UNITED STATES PATENT AND TRADEMARK OFFICE

APPLICATION NO.	FILING DATE	FIRST NAMED INVENTOR	ATTORNEY DOCKET NO.	CONFIRMATION NO.
10/769,364	01/30/2004	John P. Vanderhoef	2601.105	7921

Office Action Summary

DETAILED ACTION

Figure 2 from Austin

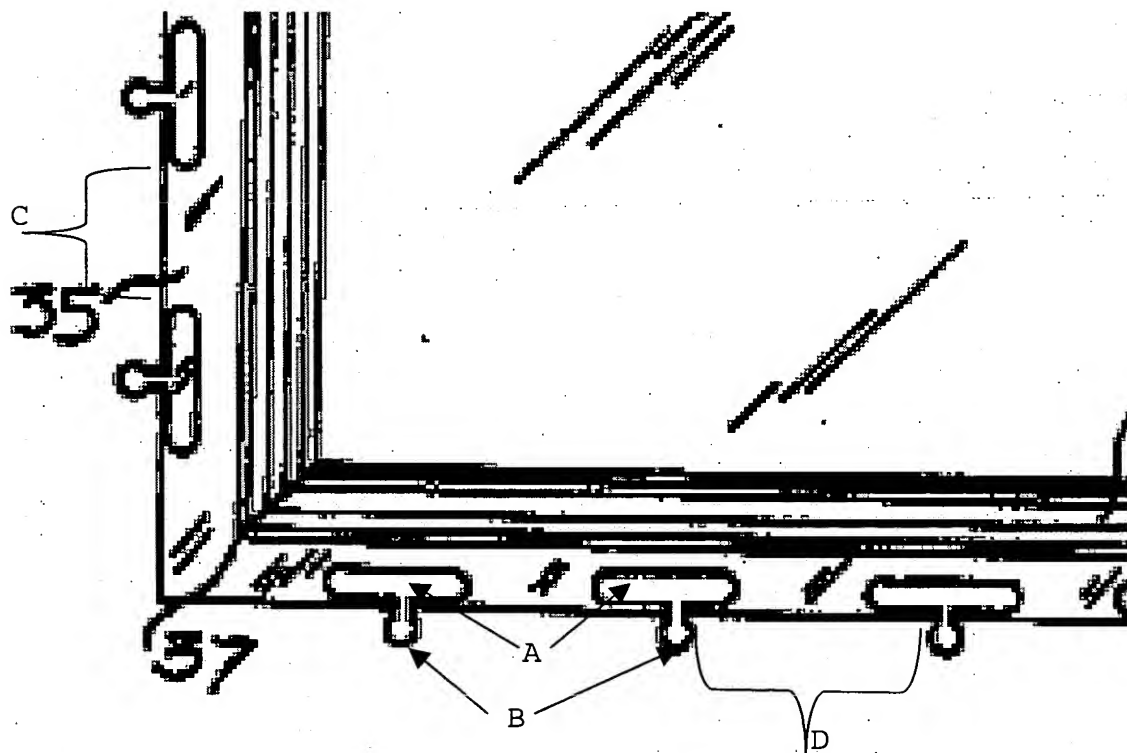
Claim 26: Austin discloses an edge interlock system (Figure 2, element 13) having a plurality of male interlock elements (see element "A" from attached Figure 2 from Austin, below), at an equal first spaced apart distance from one another along a mid section of the edge, a second plurality of male elements (see "B" below) at a second spaced distance, and the second

distance is greater than the first distance, with inverted identical interlock systems (Figure 2, element 41).

Claim 27: a first open channel section ("C" above) traverses along the edge between the first interlock elements ("A" above) and a second channel ("D" above) is between the second elements and the second channel has a greater width than the first channel, and it extends from the mid-section.

Claim 28: the second interlock elements ("B" above) are disposed adjacent opposite ends of the edge (Figure 2, generally).
